PRODUCT/PROCESS CHANGE NOTICE (PCN)

PCN #: A1401-01 Product Affected: 5.0mm x 7.0mm CDIP-10 Date Effective: 7-Jun-2014	DATE: 7-Mar-2014	MEANS OF DISTINGUISHING CHANGED DEVICES: <input checked="" type="checkbox"/> Product Mark <input type="checkbox"/> Back Mark Change in capacitor is traceable through assembly lot code. <input type="checkbox"/> Date Code <input type="checkbox"/> Other
-------------------------------------------------------------------------------------------------------------------	-------------------------	-----------------------------------------------------------------------------------------------------------------------------------------------------------------------------------------------------------------------------------------------------------------------------

ATTACHMENT I - PCN # : A1401-01

PCN Type: Alternate Capacitor
Data Sheet Change: None
No change in moisture sensitivity level (MSL)

Detail Of Change:

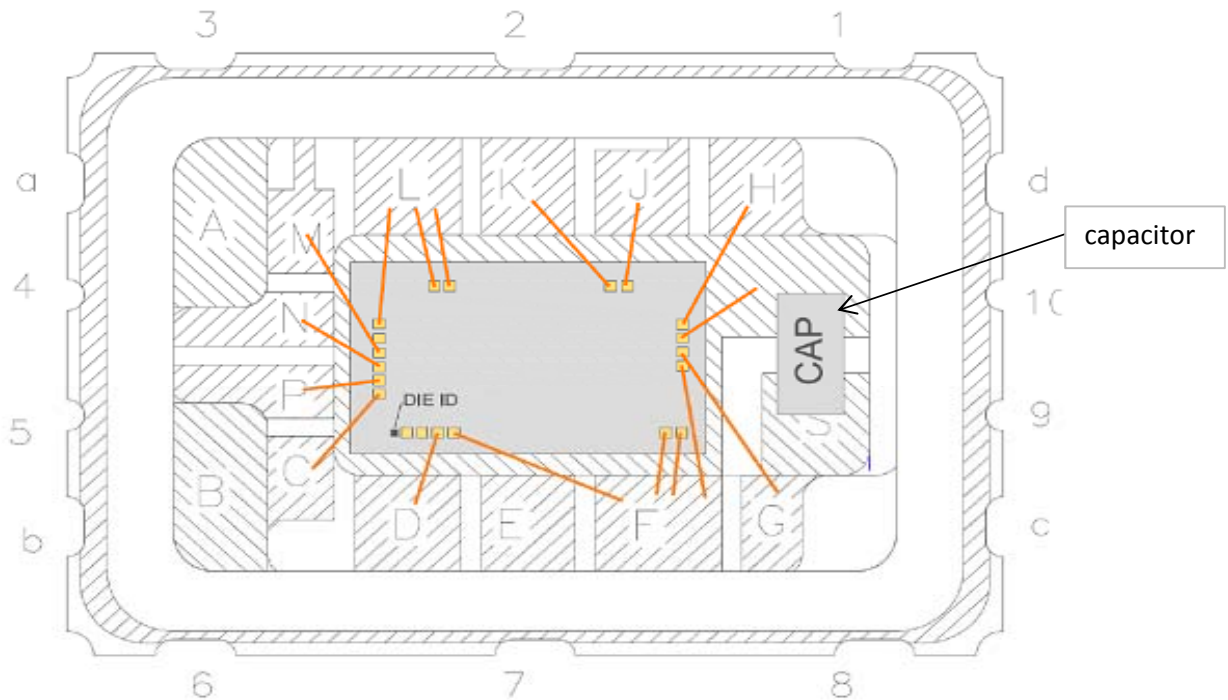
This notification is to advise our customers that IDT has qualified an alternate capacitor used internal to the package of 5.0mm x 7.0mm CDIP-10. Refer to below illustration.

This alternate capacitor was designed with these key features:

1. End cap shape to optimize mounting with conductive cement.
2. Reduce the use of gold.
3. Exceptionally high reliability for the auto industry application.
